CITY PLANNING COMMISSION

- APPLICATION:**
- A. Negative Declaration
 - B. Special Permit for an existing 3,705+ sq. ft. church and a 1,440 sq. ft. classroom addition
 - C. Variance to waive the required 6 foot masonry wall along the east and west property lines on 0.92+ developed acres in the Standard Single Family-Executive Airport Overlay 4 [R-1(EA-4)] zone

LOCATION: 2900 29th Avenue

PROPOSAL: The applicant is requesting the necessary entitlements to allow an existing church and a classroom addition.

EXHIBIT B

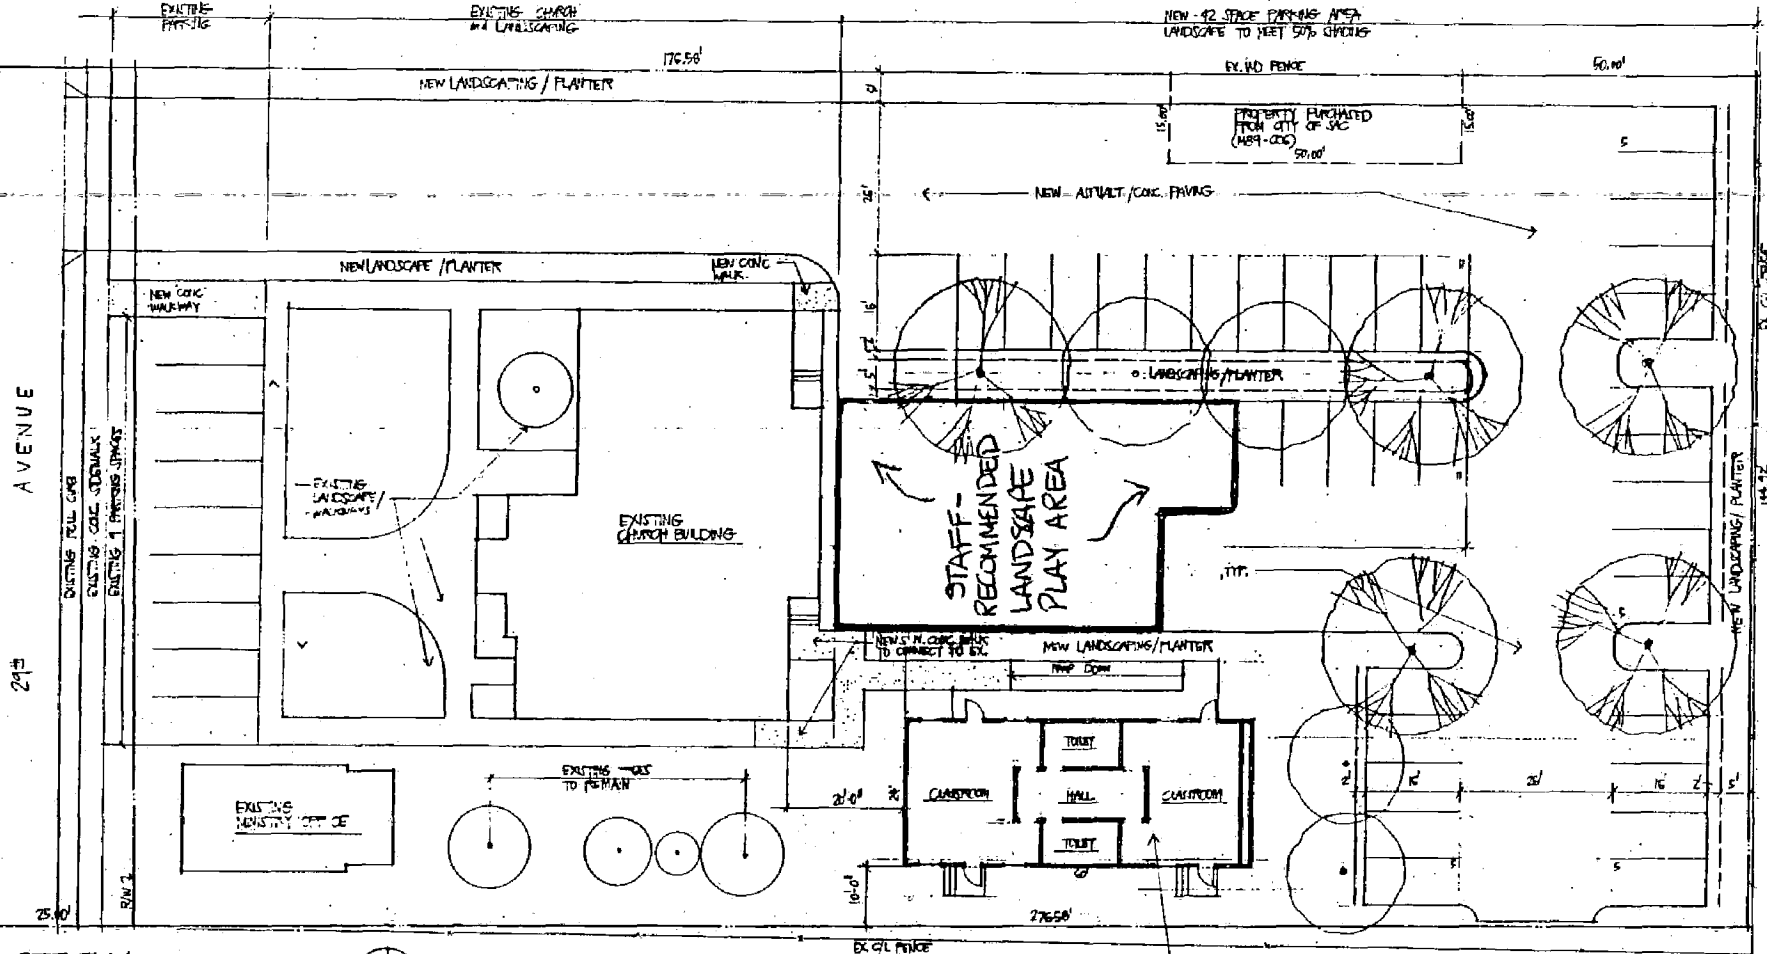
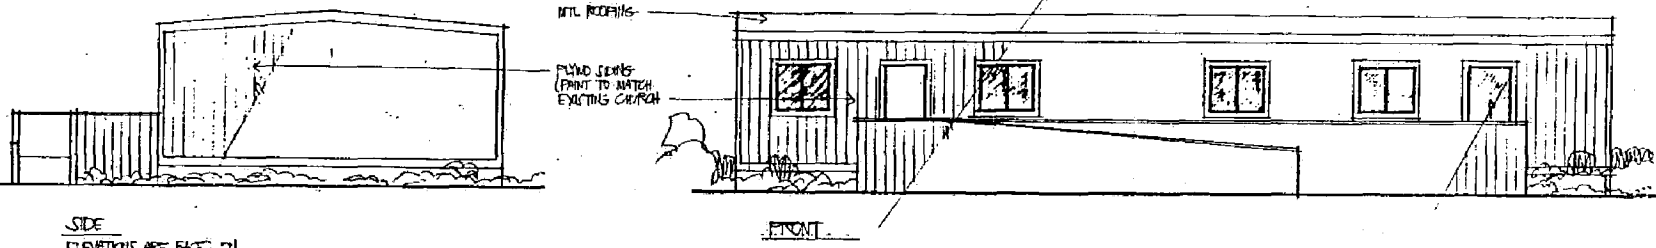
The church has a capacity of approximately 100 people. At the required ratio of one parking space for every six seats, 17 parking spaces are required. The proposal includes 51 parking spaces, 9 in the front and 42 in the rear. Staff recommends, due to the over abundance of parking, that the parking layout be altered in order to allow more landscaped open area around the classroom addition (see Exhibit B). Staff also suggests the nine parking spaces in front, which back out onto the street, be removed and replaced with landscaping for safety reasons, if feasible.

The applicant shall meet the 50 percent shading requirements of the Zoning Ordinance and increase the landscaped area as shown in Exhibit B.

1. Driveway is to be 10 feet from the property line.
2. Existing stalls on 29th Street do not comply with City Standards.
3. Round out ends of landscape planter in center of parking area.

1. The addition shall be compatible with the existing church.
2. The parking layout shall be altered as per Exhibit B.
3. The parking area shall be paved to City standards.
4. The applicant shall meet the 50 percent shade requirements of the Zoning Ordinance.
5. Additional landscaping shall be provided for the classroom addition, as per Exhibit B.
